CRYSTAL RESIDENCES PLANNING DIVISION APPLICATION TABLE OF CONTENTS

Re: Crystal Residences / Statement of Use / Planning Division Application / Property located at 110 Phoenetia Avenue, Coral Gables, Florida (Folio No. 03-4108-009-1840) (the "Property")

PLANNING DIVISION SUBMITTAL
Revisions April 17th, 2026

A-1.07

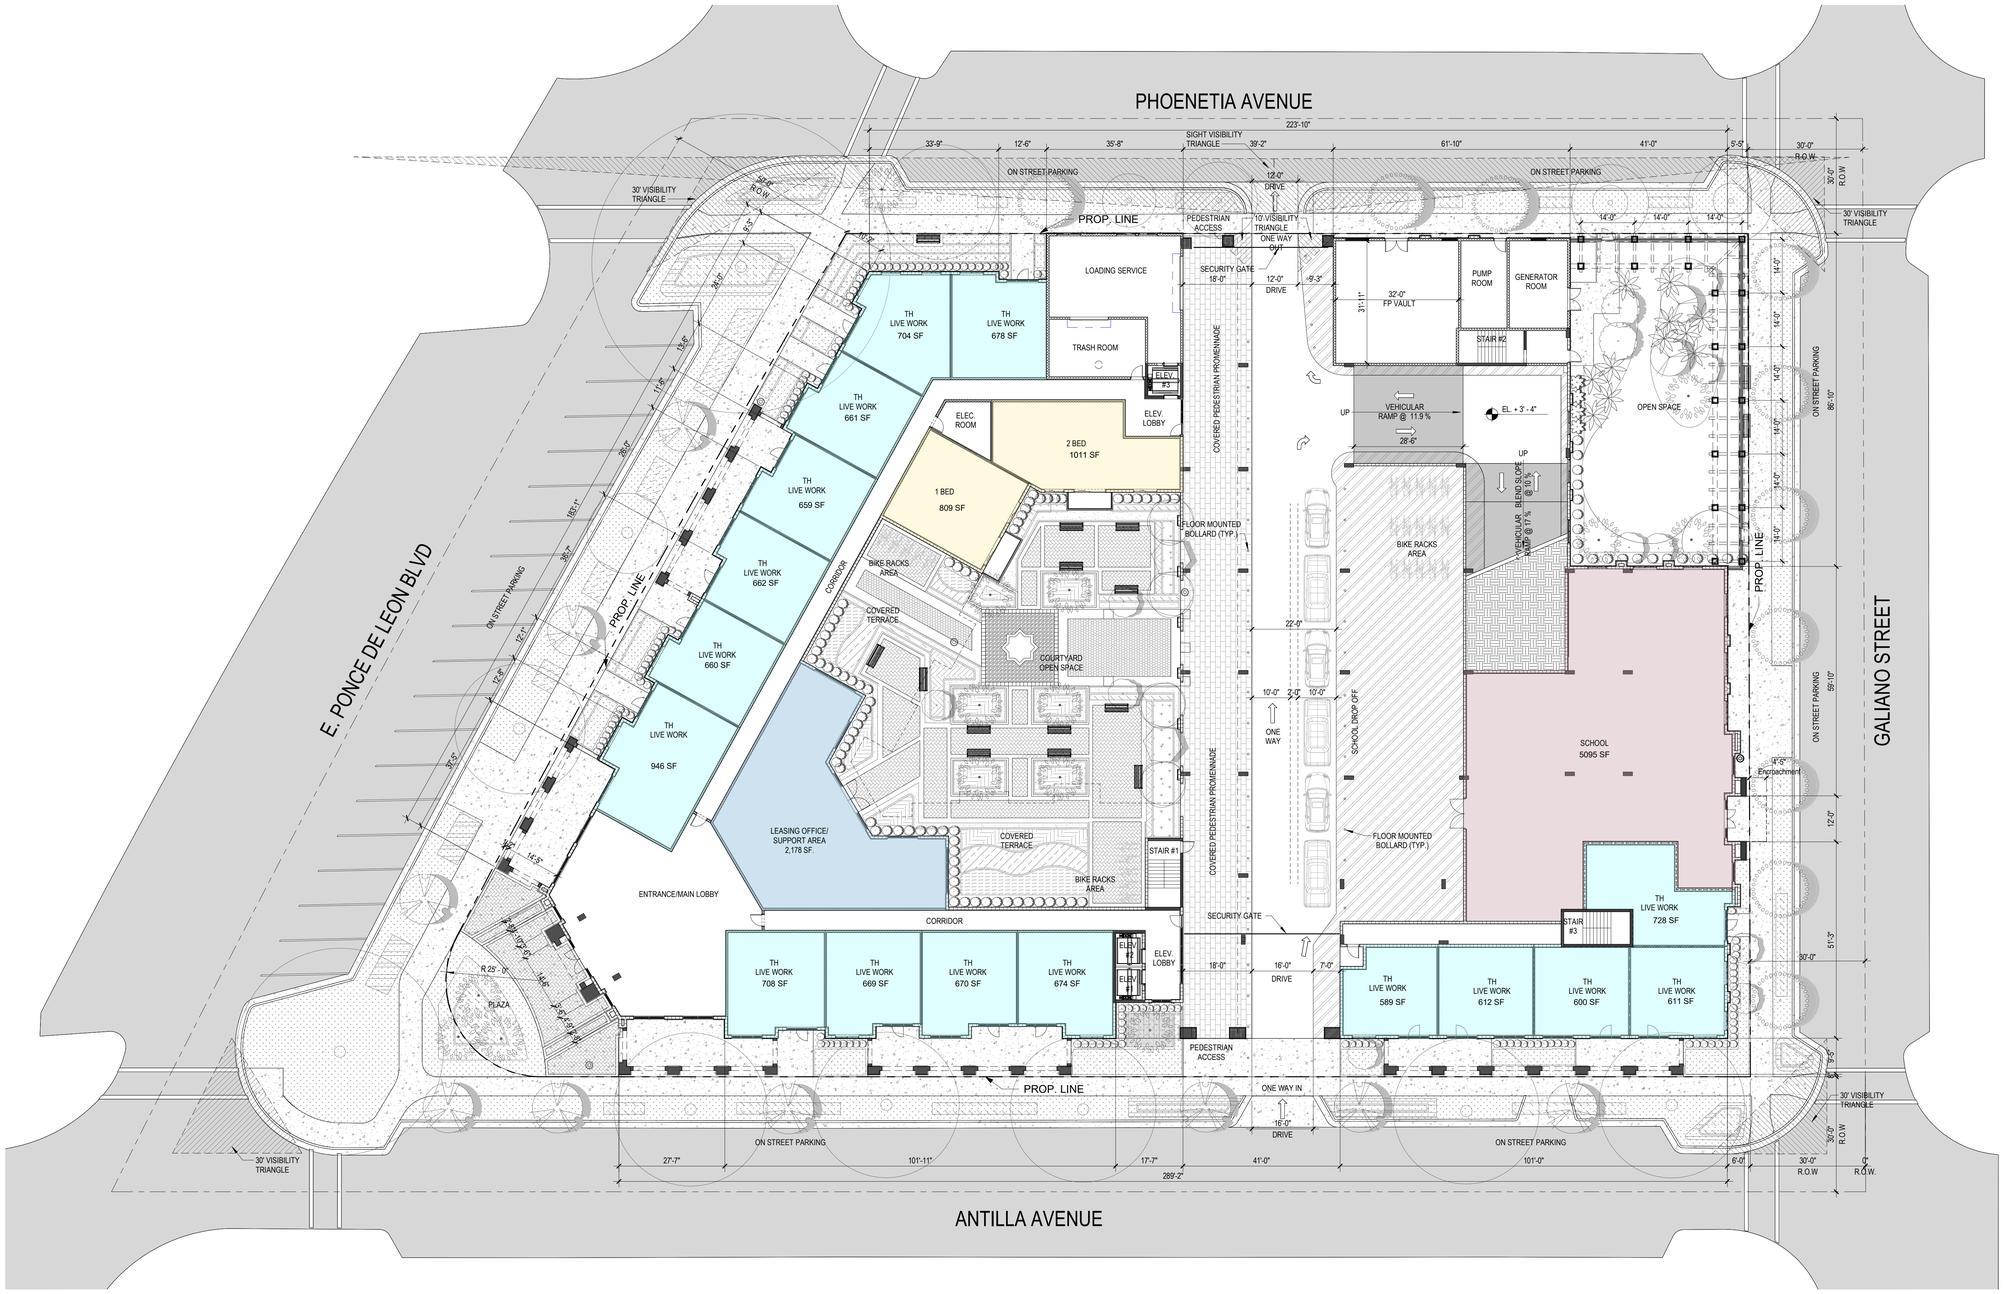
2. School's entrance canopy cantilevers into the right-of-way. Include the encroachment request to the City Commission with this submittal.	Encroachment specifications have been added; please refer to enclosed Sheet A-1.07 of updated Architectural Plans.

A-2.01

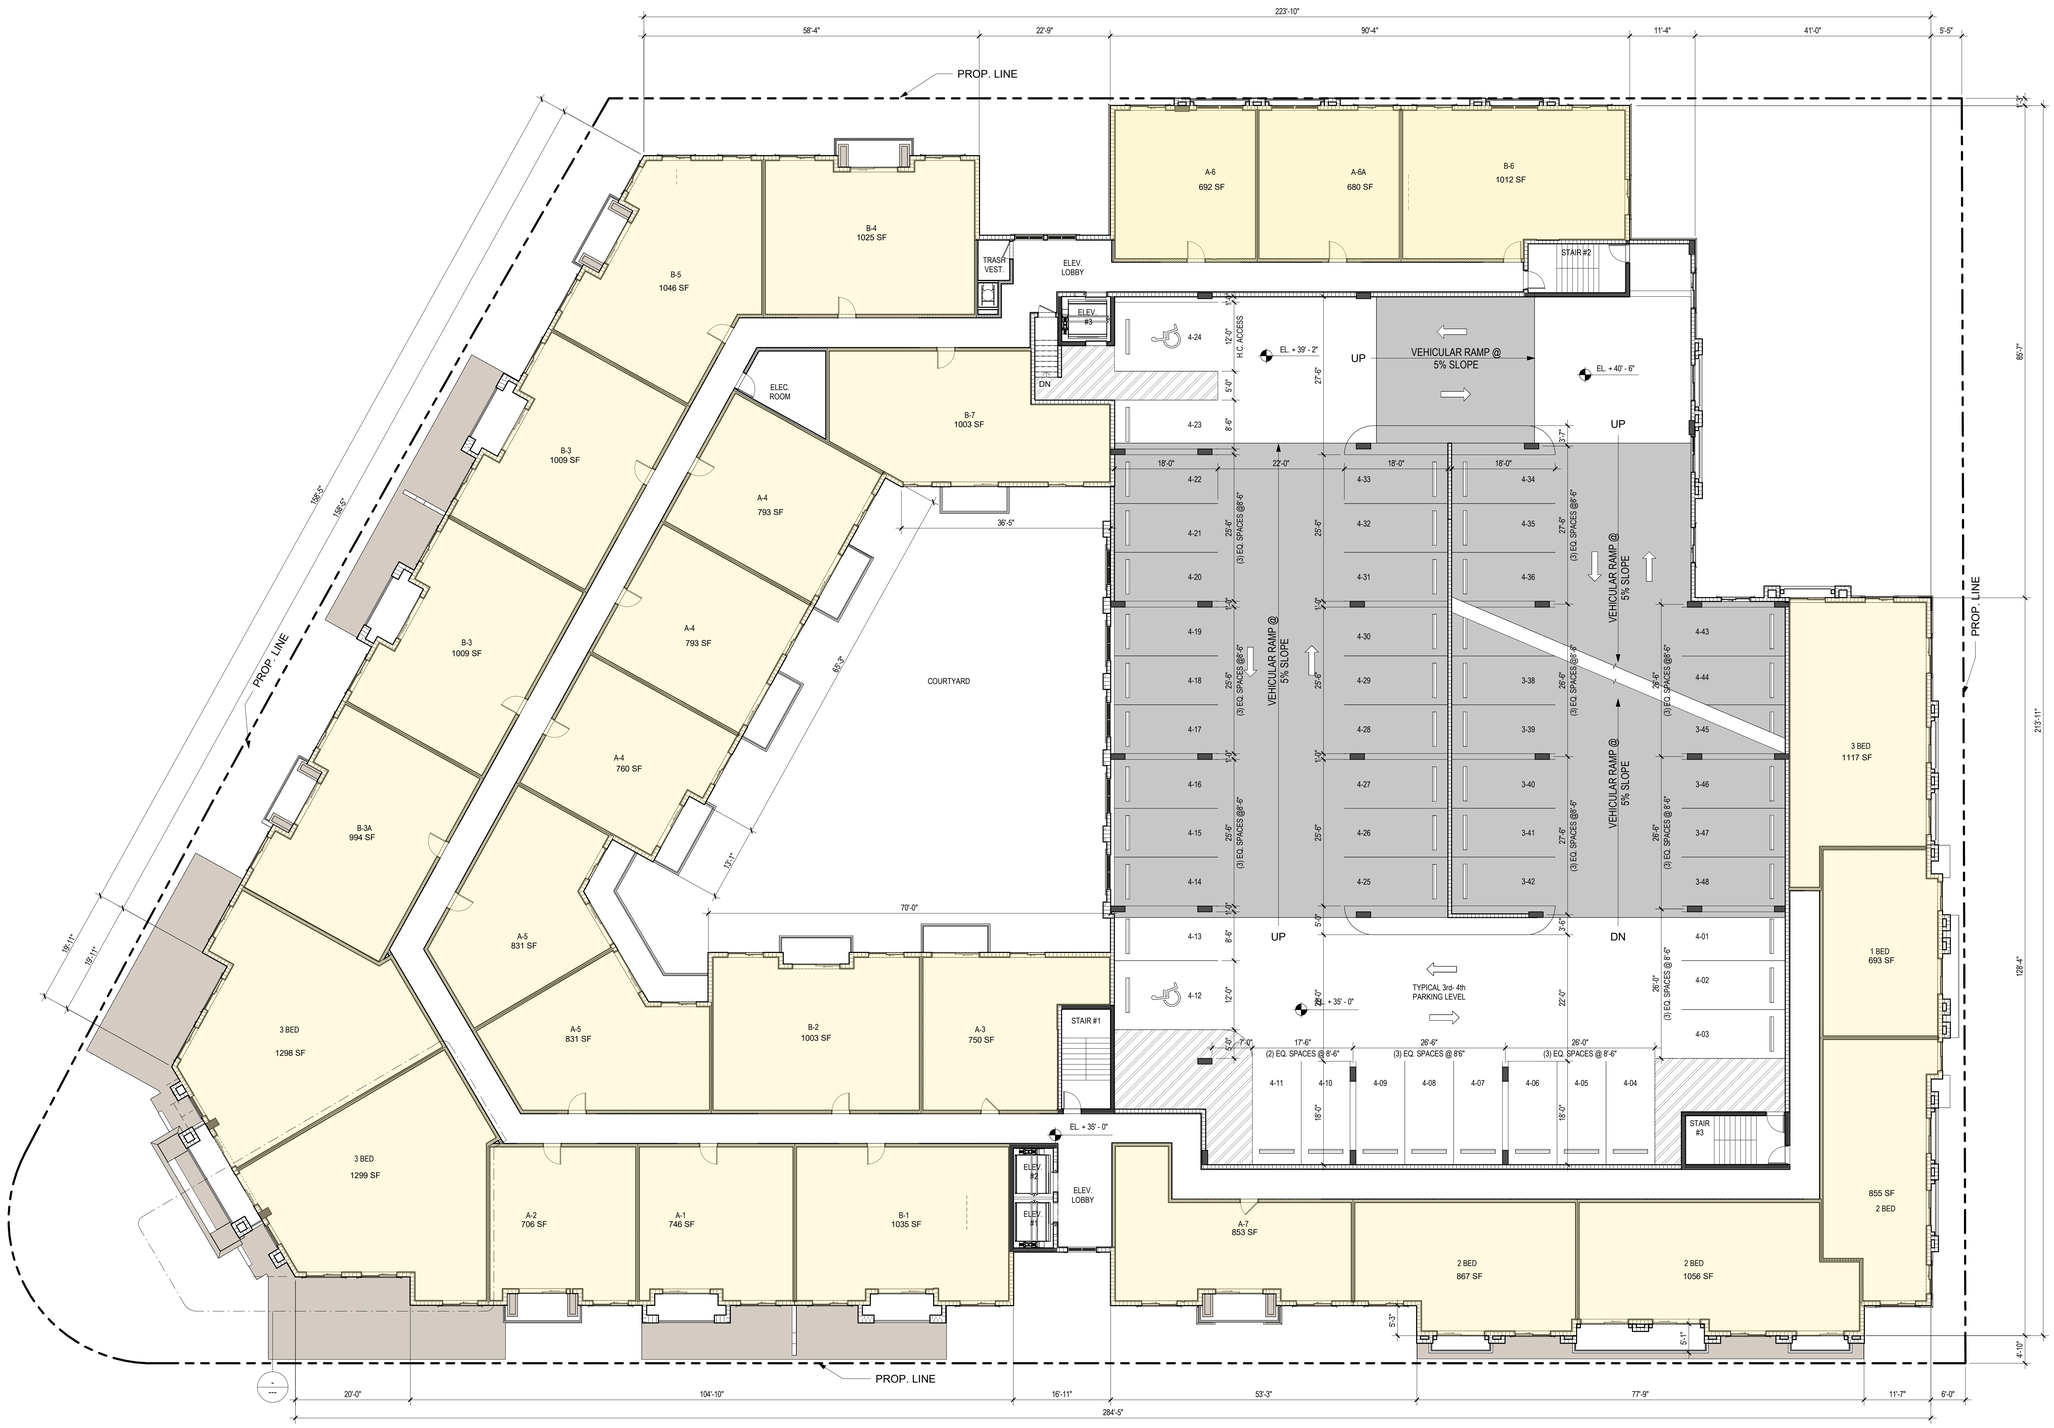
- Clarify any proposed encroachments into the public ROW. Update sheet A-2.01 on the east and north frontage accordingly
  Noted: Plans were revised reflecting no proposed building encroachments. See Sheets A-2.00 through A-2.05.
- Per Sec 10-110, parking requirements for 2 bedroom units = 1.75 spaces per unit, and 3 bedroom units = 2.25 spaces per unit. 1.5 spaces per unit is provided for both; revise drawings accordingly.
  Noted: The Project Data Table has been updated with the applicable parking requirements, see Sheet A-1.03.
- Include a master signage plan for any proposed signs.
  Noted: Signage Plan will be included during permitting process.
  Include dimensions on elevations to confirm building height.
  Noted: Dimensions were added to all elevations, see Sheets A-3.00 thru A-3.03.

TREE DISPOSITION PLAN

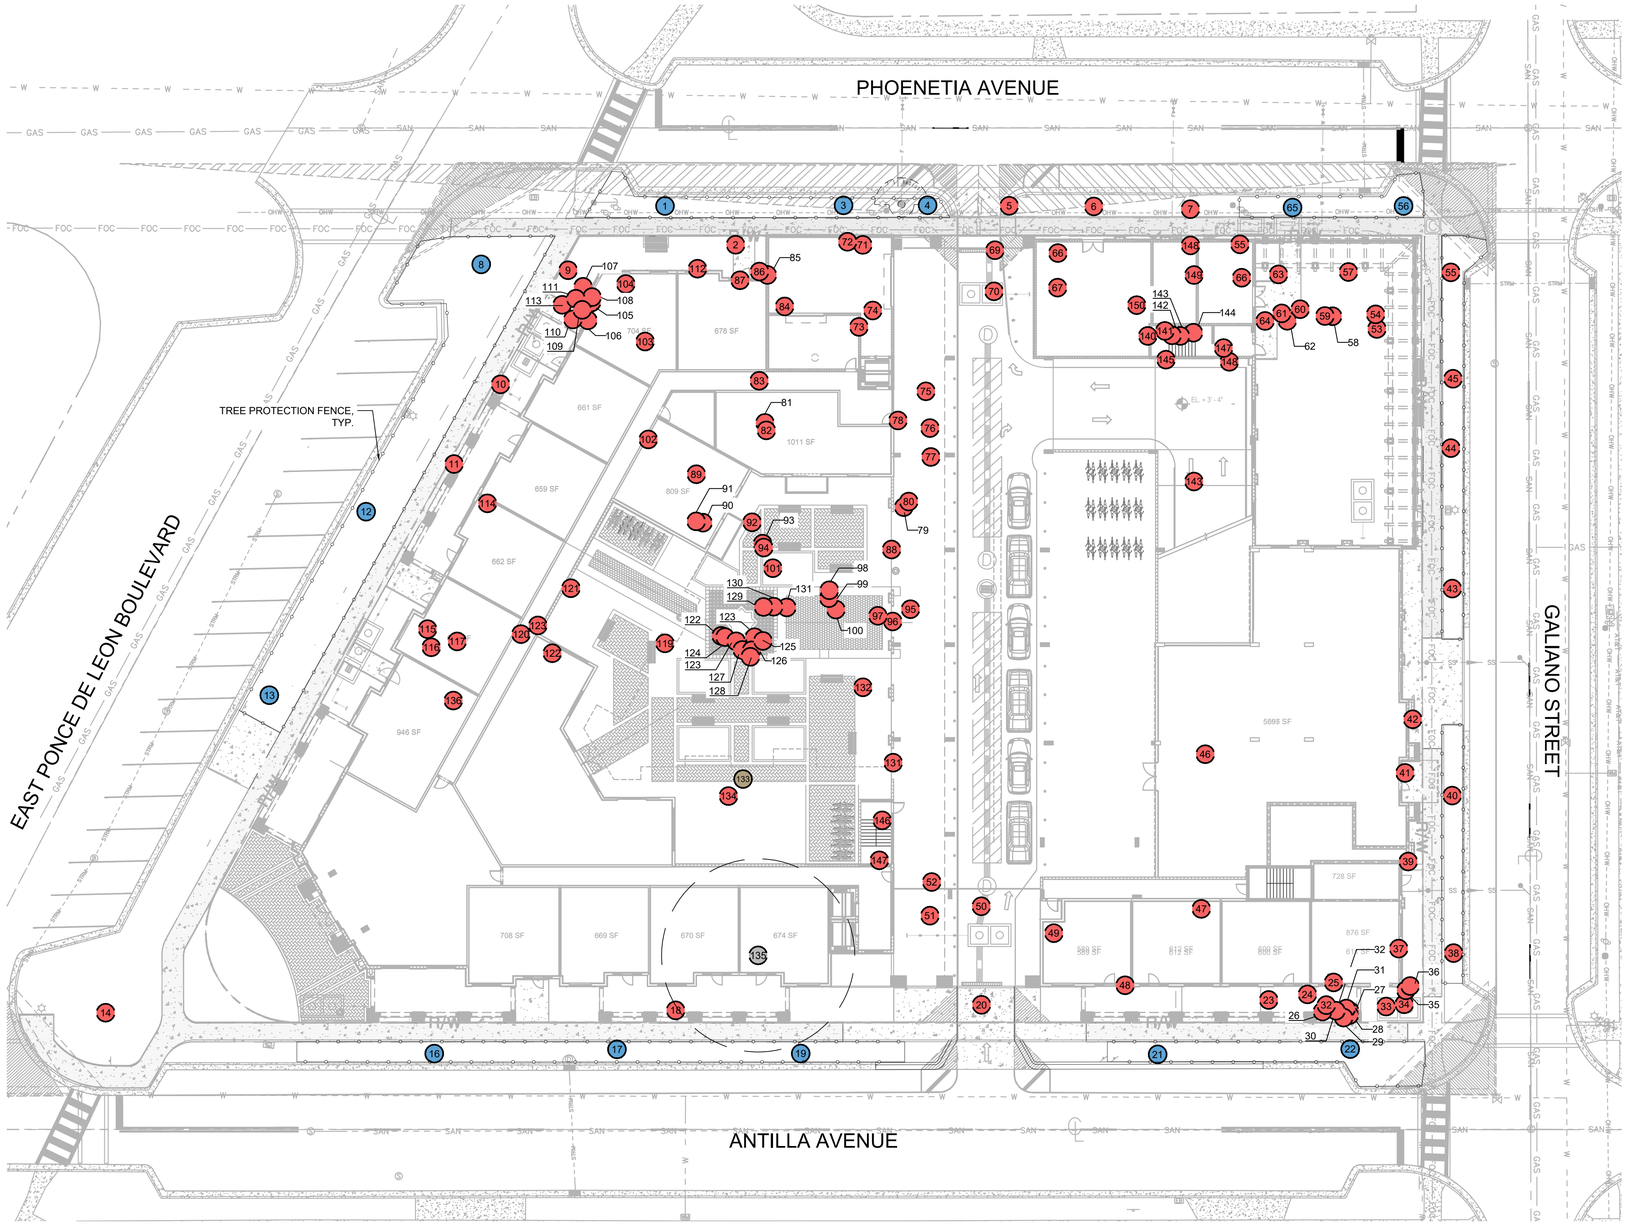
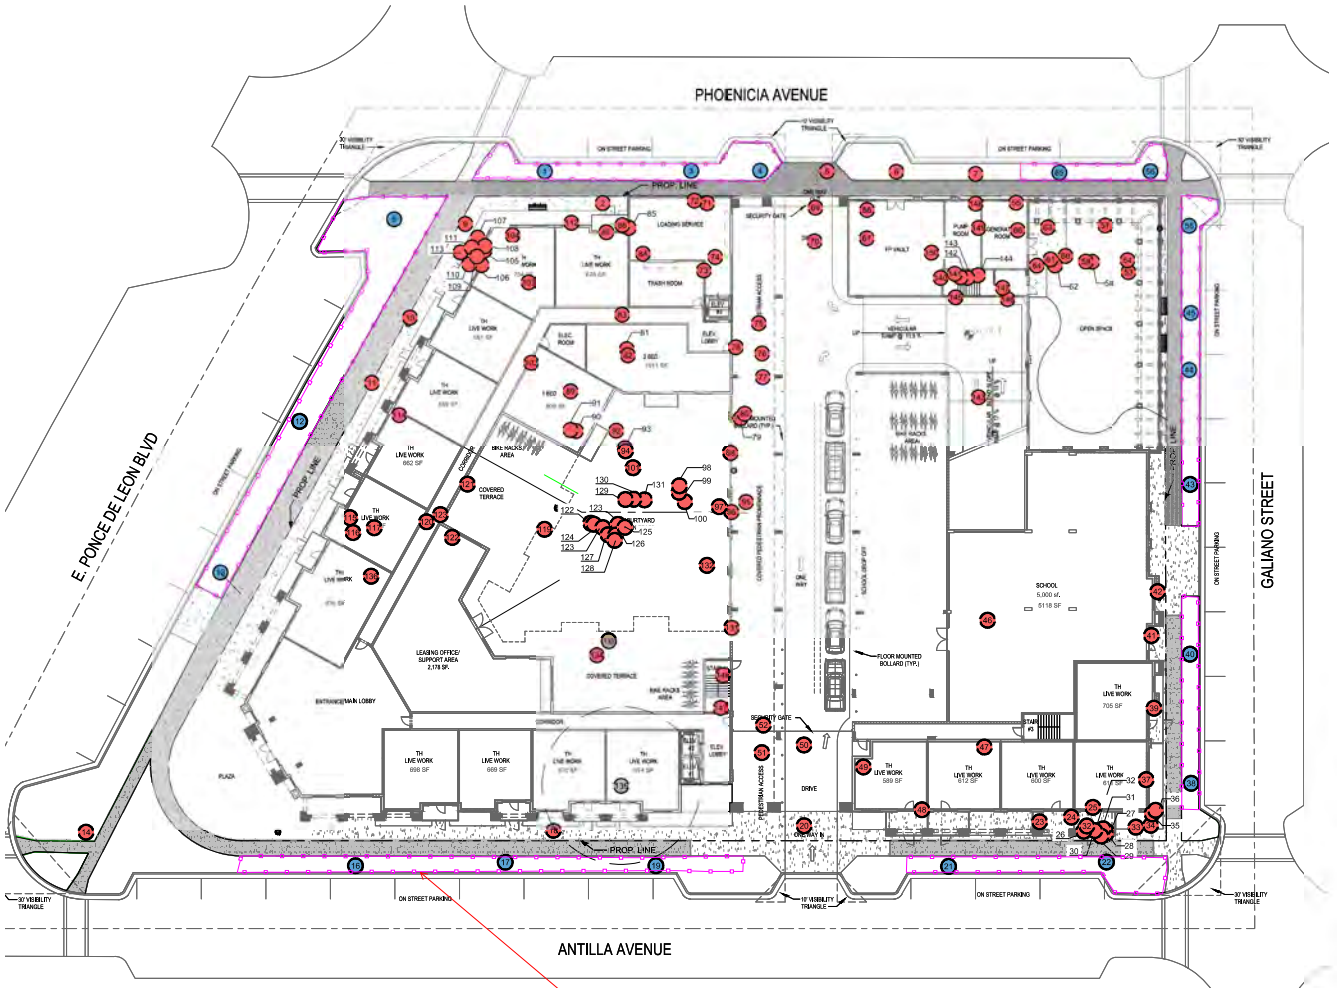
- Greenspace Management Corrections - See comments in corrections for submittal with the building permit.
    - Provide a tree survey of existing trees on site and right of way. Refer to section 82 of the city code.
      A tree disposition plan and relocation plan has been submitted that reflects the protection plan for on site trees (Sheets TD-1 and TD-2).

- Provide existing tree disposition plan outlining mitigation and protection.
      A tree disposition and relocation plan has been submitted that reflects the protection plan for on site trees (Sheets TD-1 and TD-2).

- Provide a tree survey and tree protection plan
  Noted: Tree survey and protection plan is provided on Sheets TD-1 and TD-2.

1. Where are sheets TD-1 and TD-2? Showing the existing trees for this project is very important. ***Noted: A tree disposition and relocation plan has been submitted that reflects the protection plan for on site trees (Sheets TD-1 and TD-2)***.

MIXED USE DIAGRAM

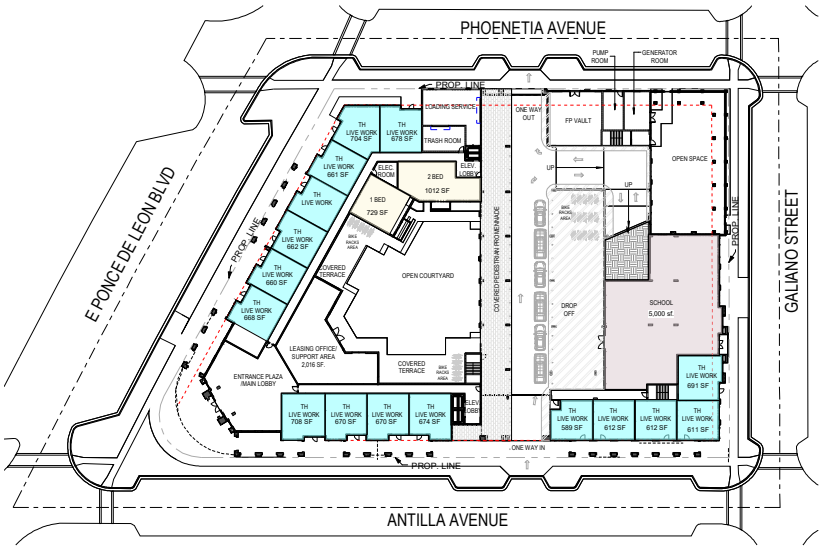
4. "Covered terraces" are not open space, remove from the open space calculations.	These areas have been removed from open space calculations; see updated Sheet A-1.06 of enclosed Architectural Plans.

6. Remove the green areas under the arcade; if its under an arcade it is not open to the sky. ***Noted: Open space diagram on Sheet A-1.06 has been updated to reflect both open space areas that are open to the sky and covered open space areas.***

SHEET NUMBER:
A-1.03

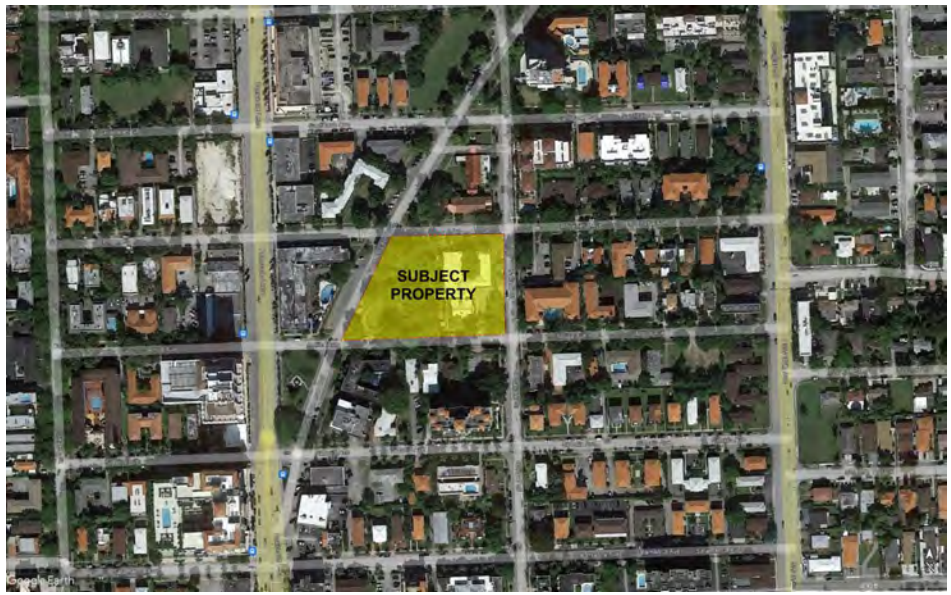
- Update Project Data on sheet A-1.03 with the following: **(1)** Include proposed maximum building coverage; **(2)** Add N/A stepback requirements for existing zoning (S); **(3)** Update Bicycle parking requirements: per Section 10-110, Bicycle parking shall be provided at a minimum of one (1) bicycle space per four (4) residential units and one (1) bicycle space per twenty thousand (20,000) square feet of non-residential use building area; **(4)** Update Mixed-Use requirements for mix of uses to Section 2-201.B(3); **(5)** Add the percentage of square feet for the mix of uses in parenthesis; and **(6)** Update spelling to "Galiano" and "East Ponce de Leon"
  Noted:
  (1) The proposed maximum building coverage is provided on Sheet A-1.03.
  (2-5) The Project Data Table has been updated and is provided on Sheet A-1.03.
  (6) Spelling has been corrected.

3. The PAD specifies certain "statistical information" be included, including "building coverage expressed as a percentage of the development site area" I understand that there is no maximum requirement for the proposed MX zoning, but I am still requesting inclusion of this information. ***Noted: proposed building coverage has been added to Sheet A-1.03.***

4. The current zoning "S" has setback requirements; it's the stepbacks that are N/A; Please include the existing setbacks in the zoning data. ***Noted: The existing setback/stepback requirements under the Special Use zoning designation have been added. Please refer to Sheet A-1.03.***

5. Remove the mixed use info under the existing "S" column. ***Noted: Removed, please refer to Sheet A-1.03.***
